COUNCIL ASSESSMENT REPORT

HUNTER AND CENTRAL COAST REGIONAL PLANNING PANEL

PANEL REFERENCE & DA NUMBER	PPS-2019HCC006– DA2018/01351
PROPOSAL	<p>Subdivision of 6 lots into: 874 residential lots; 7 development lots for future residential development; 14 Local Centre Lots; 1 Neighbourhood Centre Lot; 2 Residue Lots; and 20 lots for road widening, public reserves and drainage reserves (proposed to be dedicated to Council);</p> <p>and</p> <p>The modification of DA2015/10393 pursuant to Section 4.17(1) of the Act to be 'Subdivision of Lot 2 in DP 1230960 and Lot 3 in DP1230960 into 292 lots, 7 large redevelopment lots ('super lots'), 4 drainage reserves, 3 public reserves and 2 residual lots, plus associated roads, infrastructure, bulk earthworks, open space and signage.</p>
ADDRESS	<p>Lot 100 DP1252590 – 144 Woodford St, Minmi</p> <p>Lot 5 DP 1230960 – 144 Woodford St, Minmi</p> <p>Lot 48 DP 115128 – 144 Woodford St, Minmi</p> <p>Part Lot 1 DP1156243 – 144 Woodford St, Minmi</p> <p>Lot 4 DP1253716 – 177 Woodford St, Minmi</p> <p>Part Lot 3 DP1230960 – 610 Minmi Rd, Minmi</p>

FIGURE 10 – Possible Land Zoning Discrepancies – South-West Area (Source – SEE Figure 10)

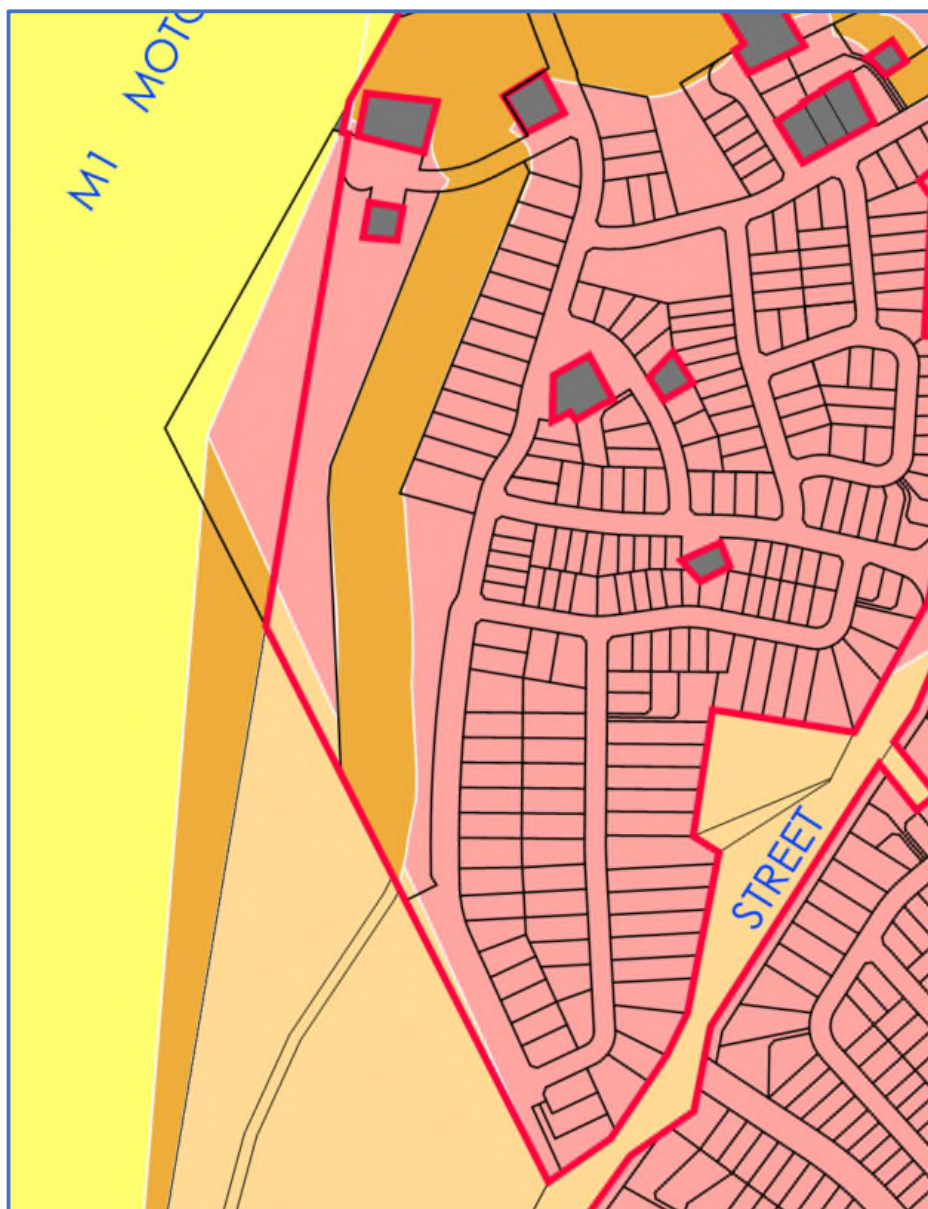
In the southwest corner of the development site, a number of seemingly unintentional discrepancies exist between the cadastral boundaries and land zone boundaries gazetted under both the NLEP2012 and the Lake Macquarie Local Environmental Plan 2014 (**LMLEP2014**). These discrepancies are evident in **Figure 10** below.

Investigations undertaken by CN and the applicant suggest the discrepancy may have resulted from the LEP maps being prepared based on the Digital Cadastral Database relied on by the DPE 'Spatial Viewer' and not based on actual boundaries derived from deposited plans.

FIGURE 14 – Showing integration of Lot 49 DP115128 (Source – Subdivision Plans, Rev. S, June 2022)

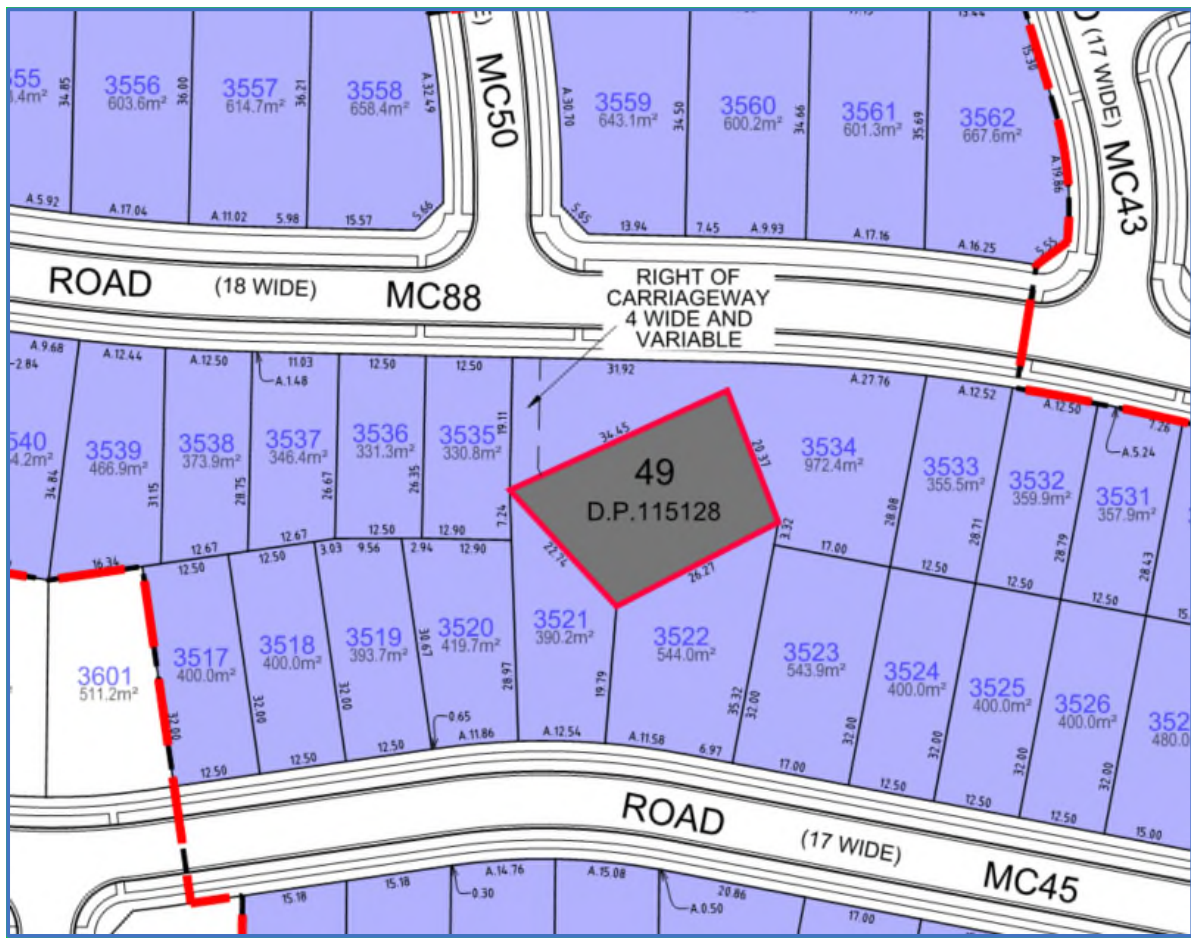
The further amended Subdivision Plans received by CN on 10 June 2022 titled 'Lot 49 in DP 115128 – Proposed Access Sketch' (Ref: 239736(3)-ESK-067, Revision C dated 10 June 2022) and on 6 July 2022 titled Subdivision Plan Stage 35 (Ref.239736(3)-DA-118 Revision S, dated 25 June 2022) show a reconfiguration of the road and lot layout across the northern frontage of Lot 49 such that it now has no legal road frontage to the proposed public road but is instead wholly enveloped by proposed new allotments. This can be seen in **Figure 14** below which shows access to only be provided by a proposed Right of Carriageway 4m wide over proposed Lot 3534.

CN and the Geographical Names Board generally require all lots to have road frontage wherever possible as this assists with house numbering, property identification and aids emergency services when responding to emergency callouts. This is not achieved by a Right of Carriageway.

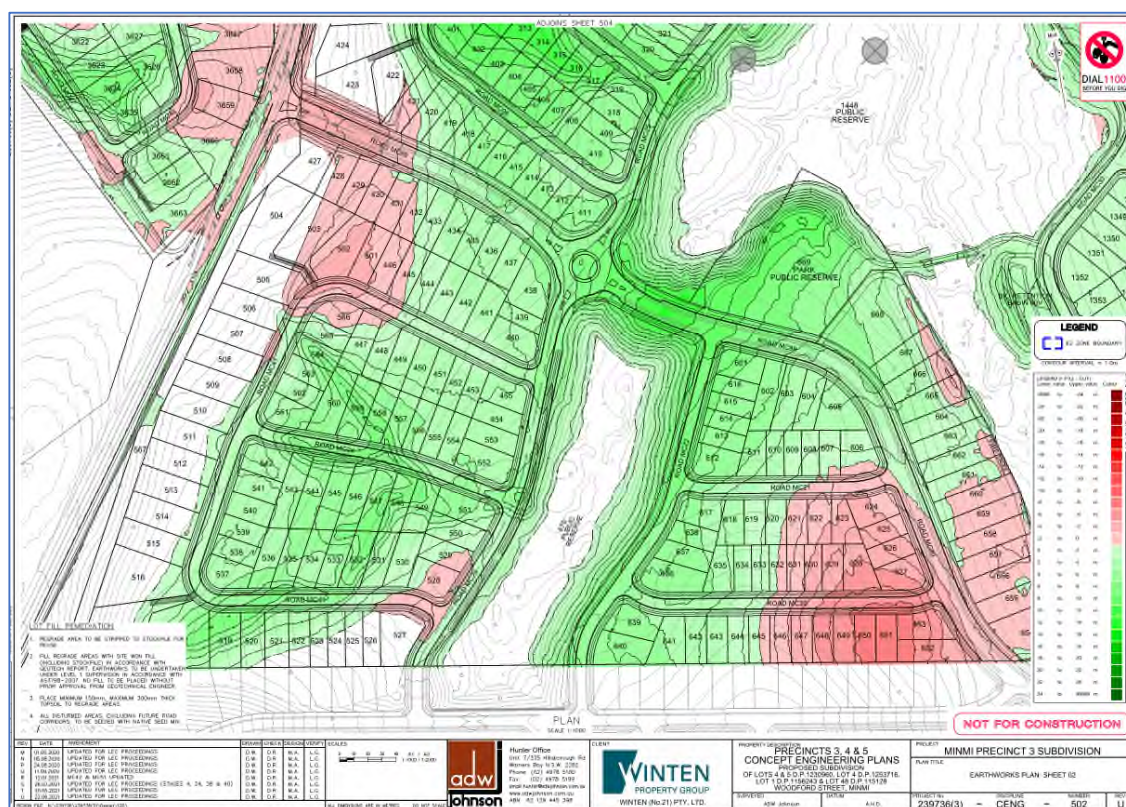
Figure 29 shows, as an example, the extent of bulk earthworks proposed in one part of the development. It can be seen that, generally, the earthworks will be limited to the areas zoned R2 except where earthworks will be necessary within areas zoned C2 primarily for the purposes of road crossings and stormwater infrastructure. It can also be seen how bulk earthworks and benching is being avoided on the lots adjacent to the eastern side of Woodford St (refer Lots 504 to 516 for example). Refer to Sheets 501 to 509 of the Concept Engineering Plans for full extent of bulk earthworks proposed.

As can also be seen in **Figure 29**, significant earthworks are also proposed adjacent the southern boundary interface with land in LMCC LGA. Where this is at its most significance, is the southeast part of the development site in Stage 14 where Drawing Sht. 501 of the Concept Engineering Plans indicates a cut depth of approximately 9m. The application is silent on how these earthworks are to be achieved in a sustainable manner without impact on neighbouring lands in LMCC LGA.

**Figure 35 – Increase in Peak Flood Depth 1%AEP, 1m tailwater, 100% blockage
(Source BMT Report, Figure 6-4)**

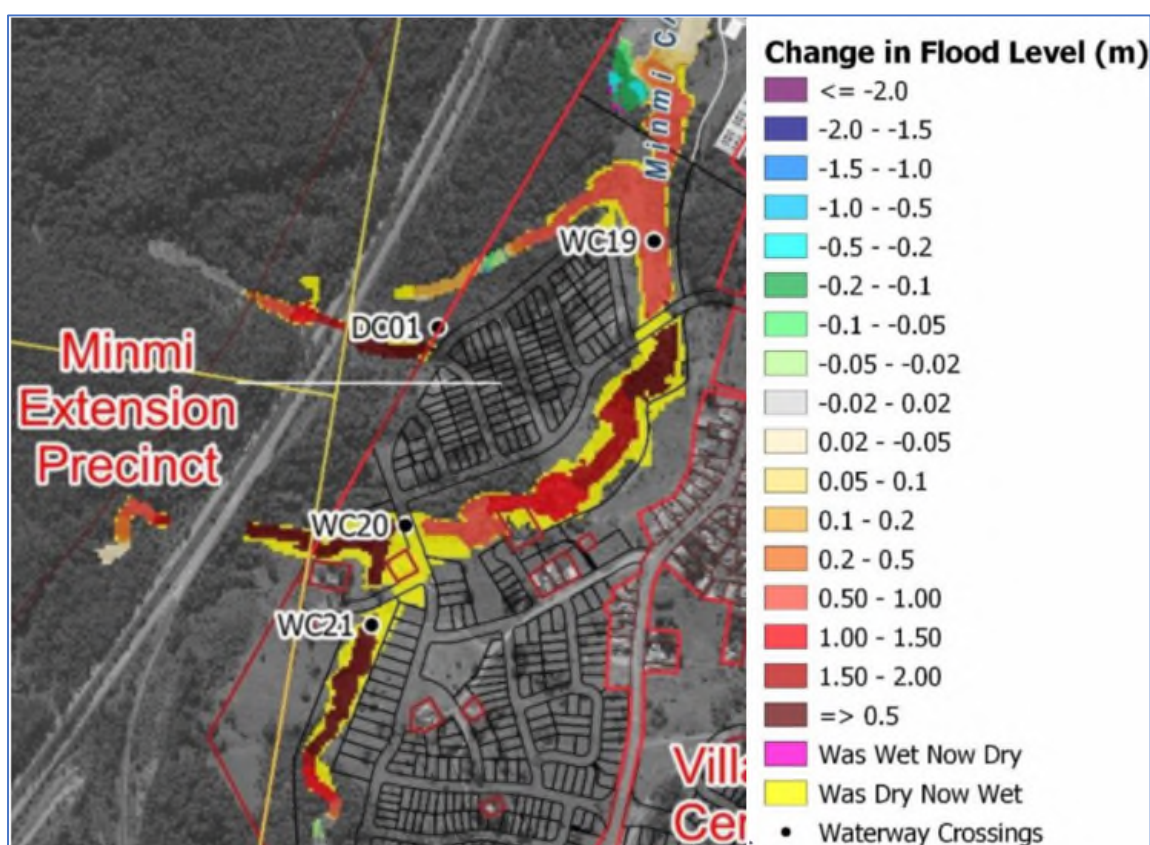
Interrogation of Figures 5-4 and 5.6 of the BMT report indicates that the proposed development will cause increases in 1% AEP flood levels in areas outside the boundaries of the site. Locations where this is evident are as follows. See **Figure 35** below showing the extent of increased flood depth (level) in the 1% AEP developed scenario assuming 100% blockage factor (see discussion below on blockage).

- Along the tributary of Minmi Creek that intersects the Minmi Extension Precinct and which is proposed as part of the development to be diverted via a diversion channel (ID DC01). The mapping in Figure 5-4 of the BMT report indicates that 1% AEP flood levels are predicted to increase in the adjoining property to the west for about 200 m and by up to 0.5 m. This is a significant impact and indicates that the development proposal does not conform to the requirements of the NSW Government's Flood Prone Land Policy as outlined in the Floodplain Development Manual (2005). Also, the extent and increase in changed flood level in this location may be further altered by the position taken by CN within this report not to support the proposed arrangements for the diversion channel (ID DC01) and the recommendation that this diversion be constructed as an appropriately sized open channel.

- Along a tributary of Minmi Creek extending upstream from waterway crossing WC20 in Figure 5-6 of the BMT report which drains the area to the west of the site. The mapping in Figure 5-4 of the BMT report indicates that 1% AEP flood levels are predicted to increase in the adjoining property to the west for a distance of about 200 m and by up to 0.5 m. This is a significant impact and indicates that the development proposal does not conform to the requirements of the NSW Government's Flood Prone Land Policy as outlined in the Floodplain Development Manual (2005).

- There may be other areas where off-site impacts occur due to the proposed development. However, due to the issues with the scale of the mapping and the thematic (colour) grading presented in Figure 5-4 of the BMT report, it is difficult to identify the magnitude of these. The modelling results would need to be made available for review to confirm that off-site impacts were limited to the two locations outlined above.

Figure 39 – Flood Planning Area Developed Scenario (Source BMT Report, Figure D1)

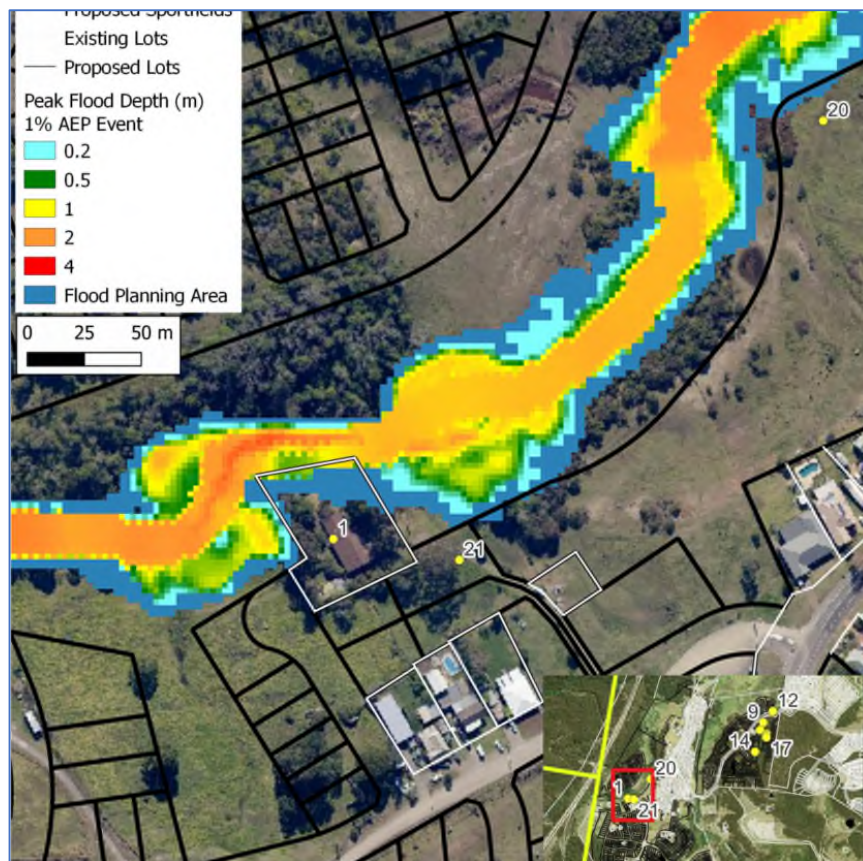
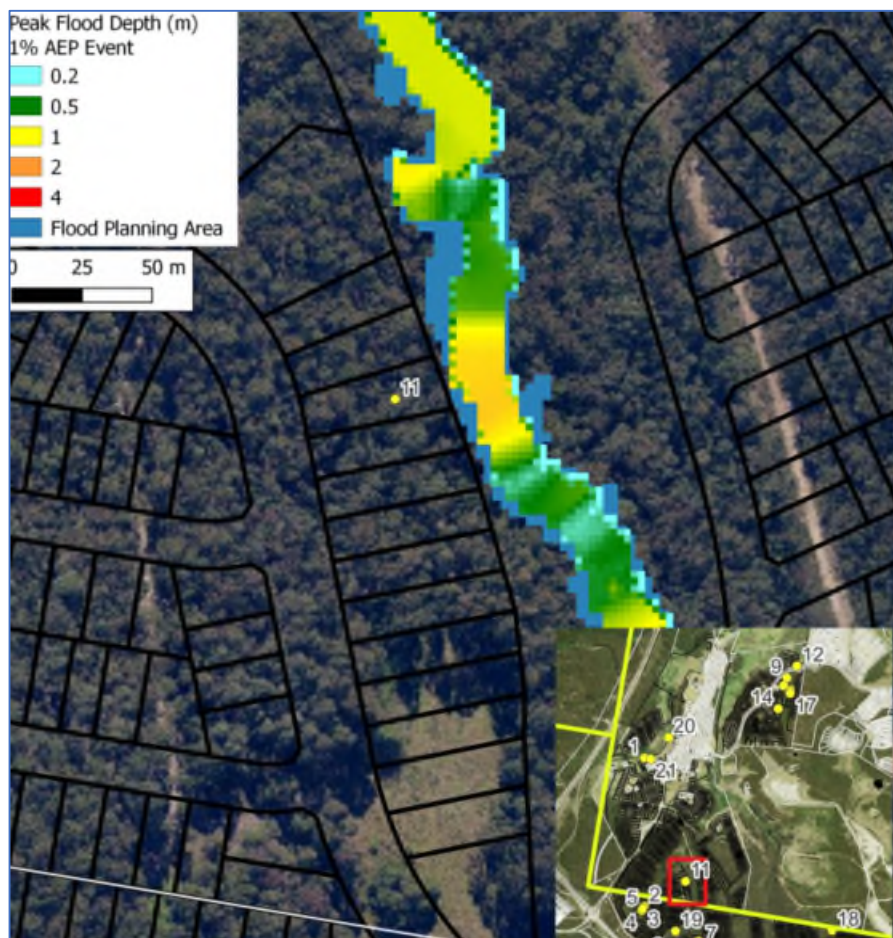
- Location 1 - 14 Railway St (existing) (see **Figure 39** below)
- Location 11 - proposed Lot 665 in Stage 6 (see **Figure 40** below)
- Location 21 - proposed Lot 3362 (Stage 33) (see **Figure 39** below)

Figure 43 - Previously proposed boundaries of Workshop Park (outlined in red). The park boundaries bisected the workshop and boilers.

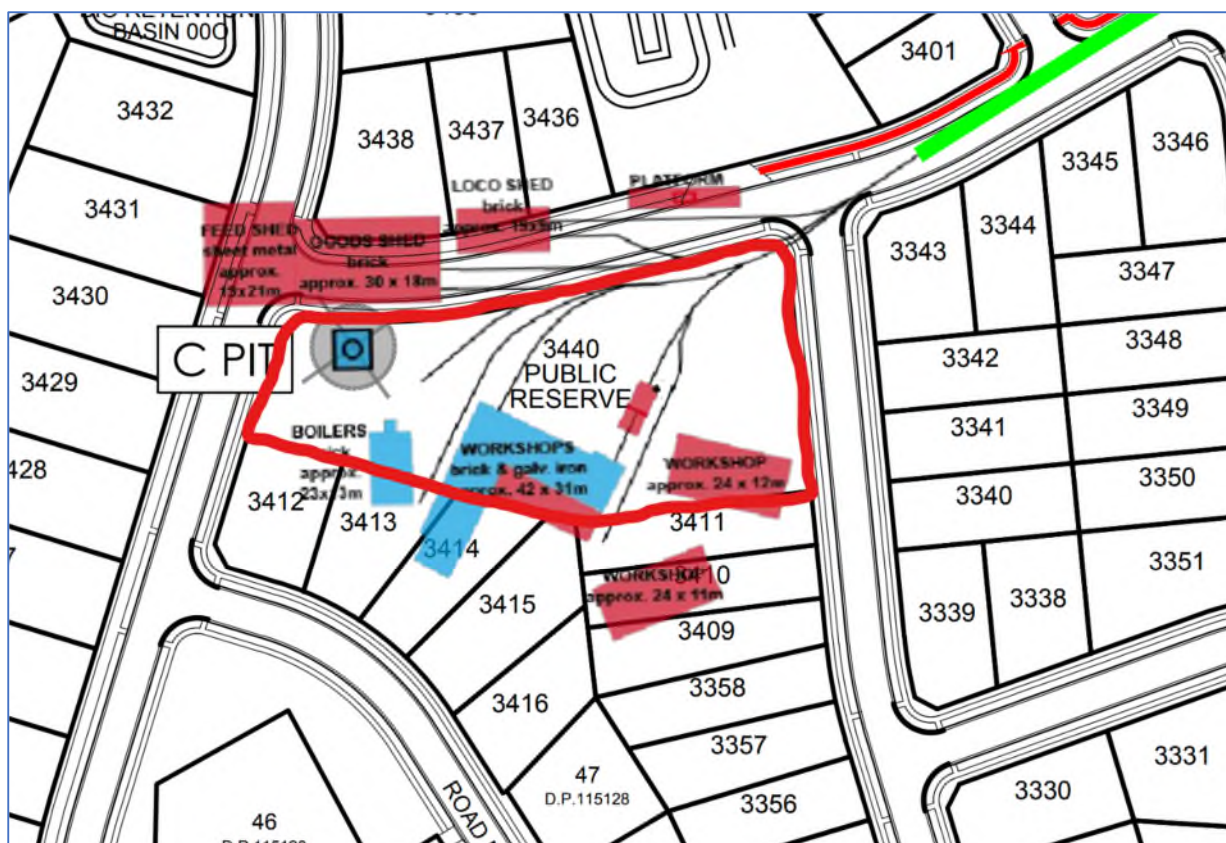
Subject to conditions, the amended park layout, being the result of additional research conducted by GBA Heritage, is considered to be a reasonable outcome. The park will provide the opportunity for an expansive heritage interpretation programme. **Figures 43 and 44** below show a comparison between the previous and current proposed Workshop Park extents overlaid on the locations determined for the former workshop buildings and structures.

Figure 47 - Comparison between approved and proposed subdivision layout DA2015/10393 (Source SEE – Modification of DA2015/10393, ADW Johnson, June 2022)

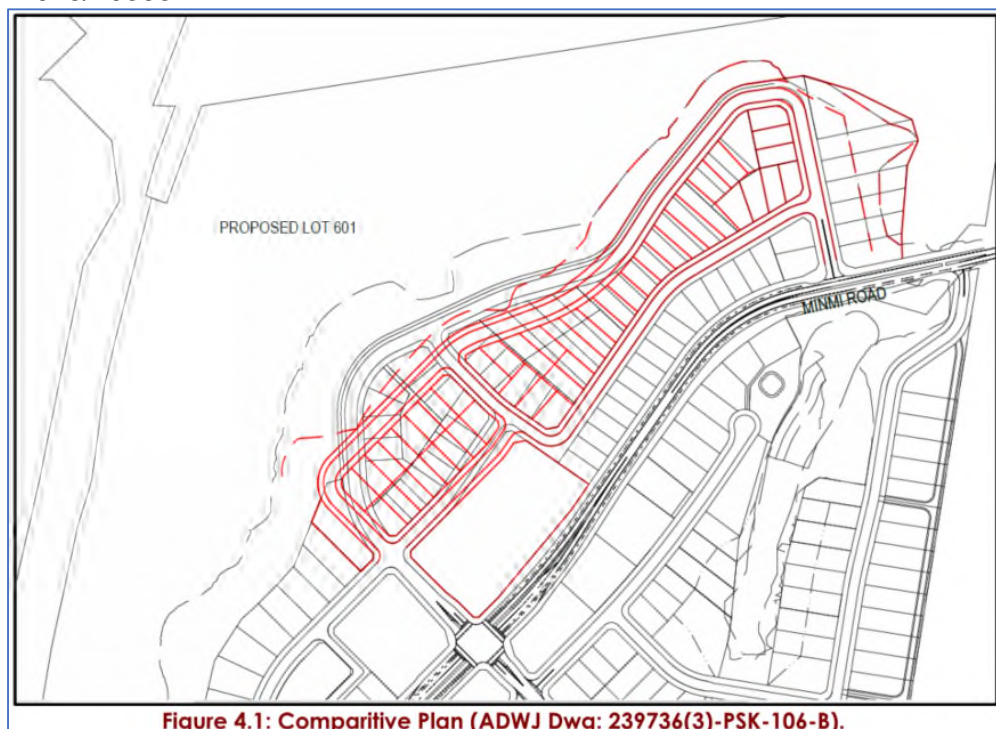
Figure 47 below shows a comparison between the existing approved subdivision layout (in black) and the proposed subdivision layout (in red). It can be seen that the footprint of the road and lot layout, inclusive of the road batter (dashed lines) is less than that currently approved under DA2015/10393.

Accordingly, CN is of the opinion that the modification to DA2015/10393, requested by the applicant to be considered in association with DA2018/01351, are satisfactory in that it would result in less environmental impact than the current approved development and could be approved subject to conditions imposed on DA2018/01351 (s4.17(1)(b)) to make the necessary modifications to existing consent conditions of DA2015/10393..
